Roland Corporation

SERVICE INFORMATION

MODEL No. DATE 1990-03-09
 DAC-15D/XD Service Information No. 100432

CHANGING VALUE OF CERAMIC CAPACITOR AND RESISTOR

PM BOARD

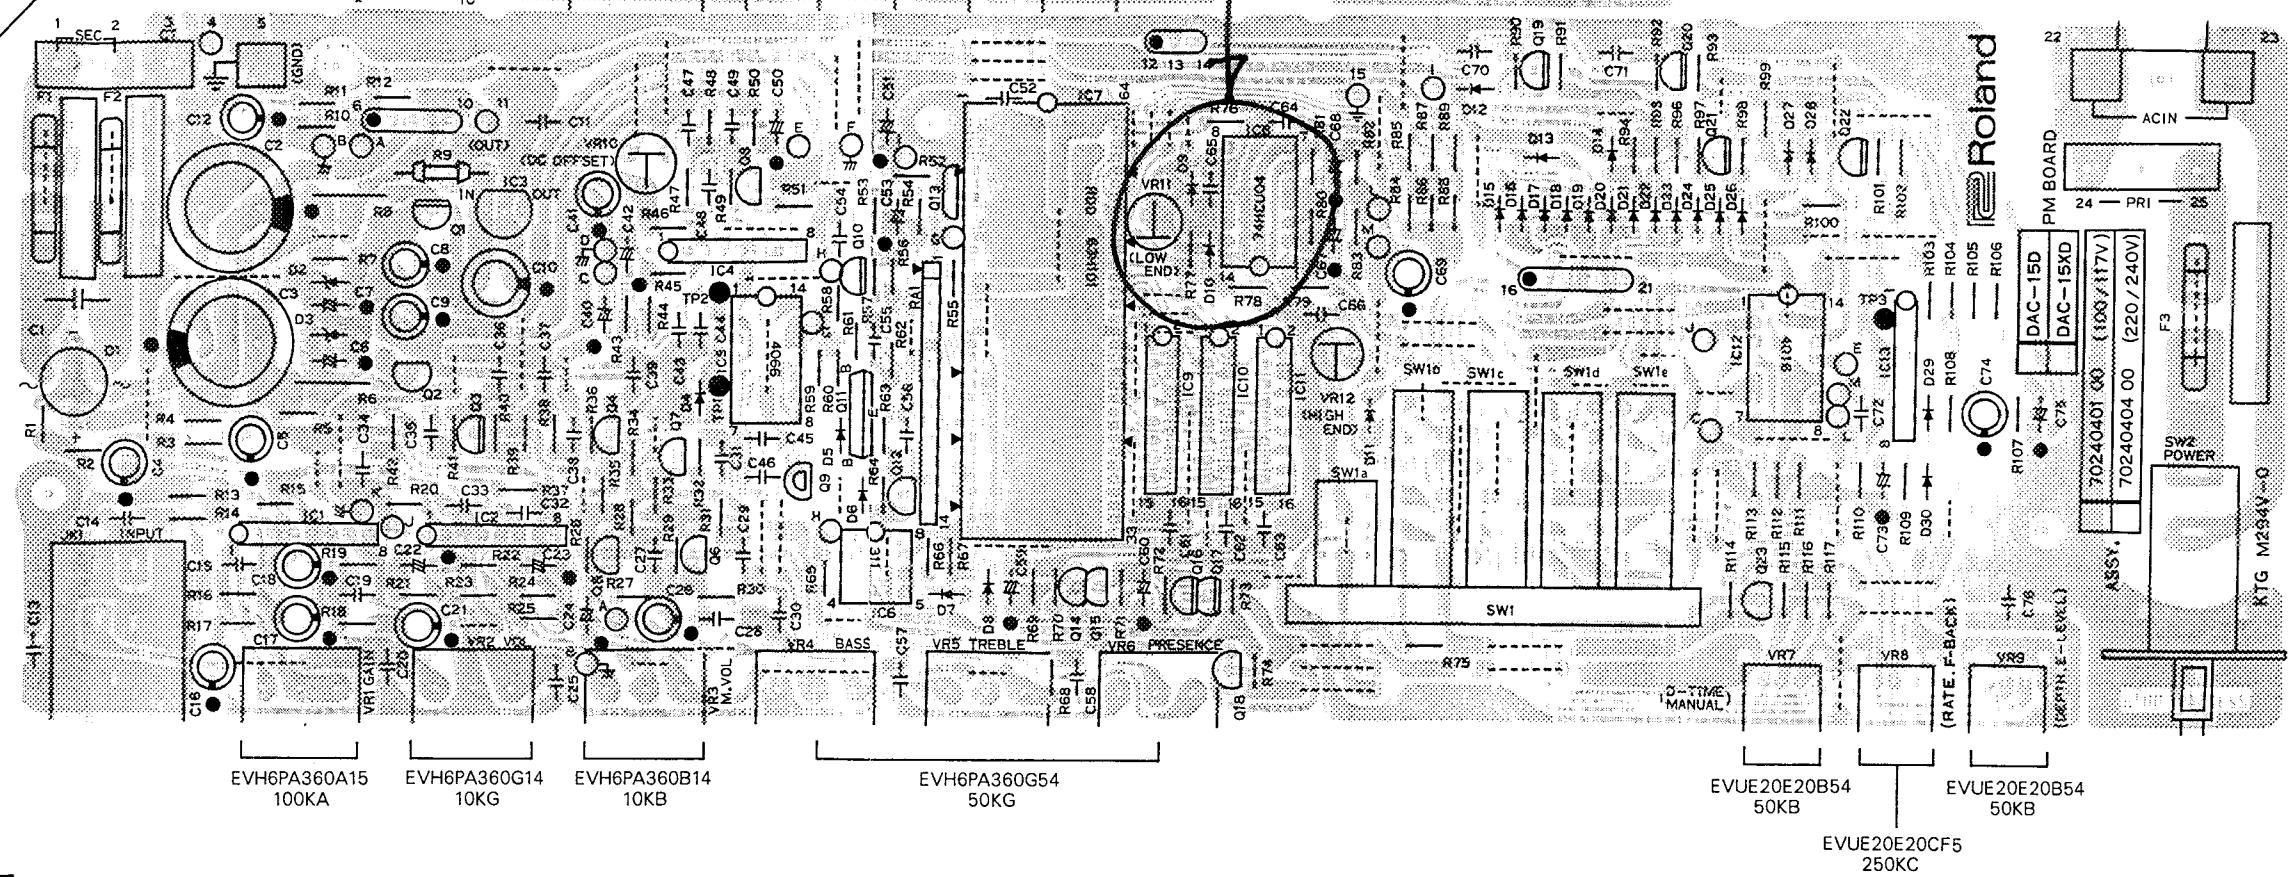
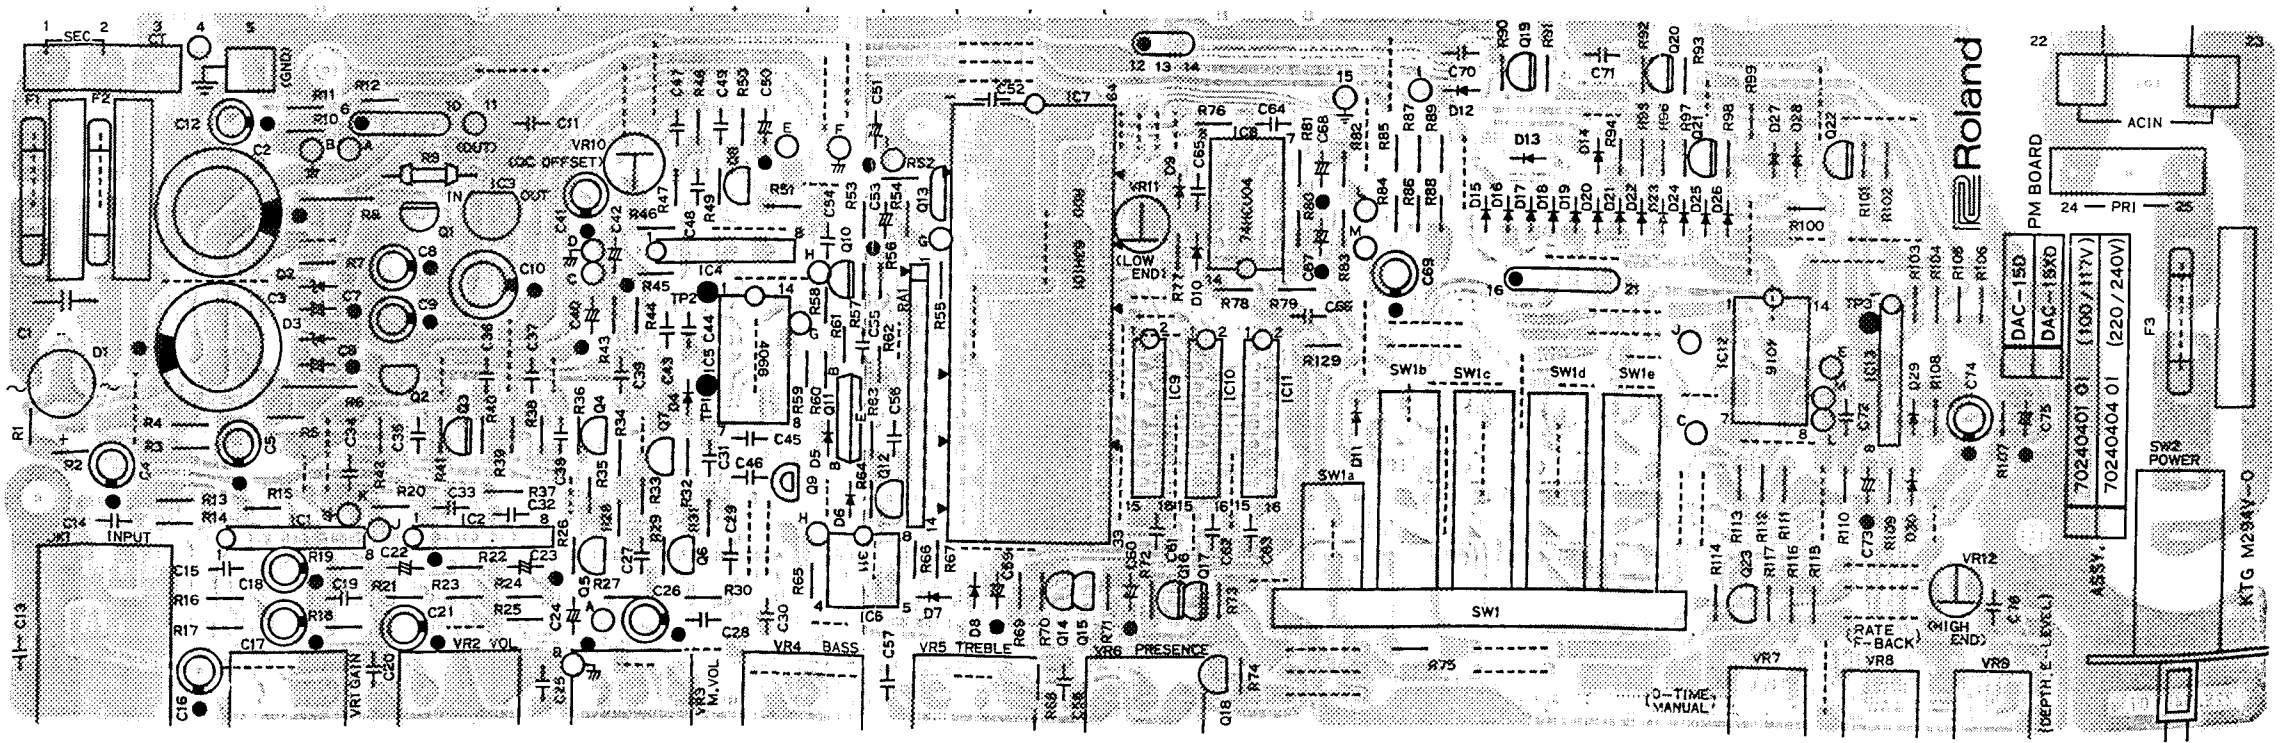
CHANGED THE CERAMIC CAPACITOR AND THE RESISTOR ON THE PM BOARD.

BEFORE	AFTER
CERAMIC CAPACITOR (C65)	10 pF	15 pF
RESISTOR (R77)	56 KΩ 1 / 6 W	47 KΩ 1 / 6 W

IC8 ON THE PM BOARD CHANGES FROM "TC74HCU04P"(PN#15169512T0) TO "TC74HCU04AP"(SAME PART CODE) BECAUSE OF NO MORE PRODUCTION.

*WHEN YOU CHANGE THE IC 8 TO "TC74HCU04AP", PLEASE DO THE ABOVE CHANGE. OR YOU CANNOT COMPLETE "VCO(LOW END, HI END)" ADJUSTMENT.
